PROPOSAL, SPECIFICATIONS, BOND AND AFFIDAVIT FOR THE CONSTRUCTION OF RESIDENTIAL STREET REHABILITATION (AREA A), I-94

B2019-55

ADDENDUM NO. 1
Issued: December 19, 2019

RESIDENTIAL STREET REHABILITATION (AREA A), I-94

APPENDIX IX
SIGN AND POST INVENTORY
AND
STREET NAME SIGN TEMPLATE

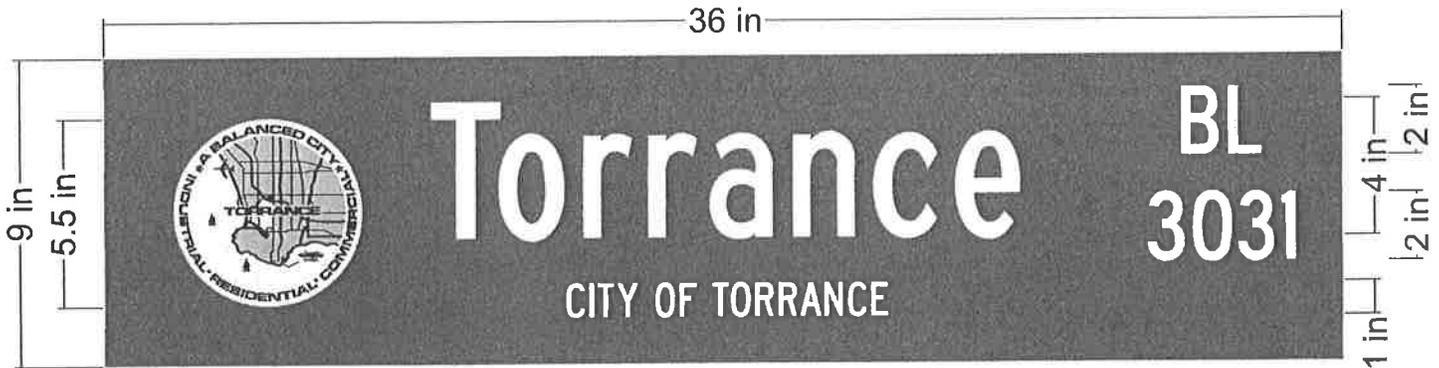
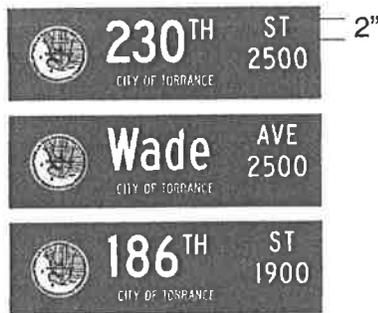
When signs are indicated on the plans to be reused, the Contractor shall carefully remove and salvage the existing sign. All existing street name signs shall be removed and replaced and new street name signs furnished in accordance with the template provided in Appendix IX. Replacement street name sign shall be manufactured by Zumar or approved equal. The Contractor shall submit a sample sign to the Engineer for approval. Once the new post is placed in its final location, the Contractor shall reinstall all existing signs and new street name signs on the new post using the approved hardware and as described in Section 315-2. Contractor will be required to replace in-kind any existing signs that are damaged during the removal at no cost to the City.

A sign and post inventory has been included in Appendix IX.
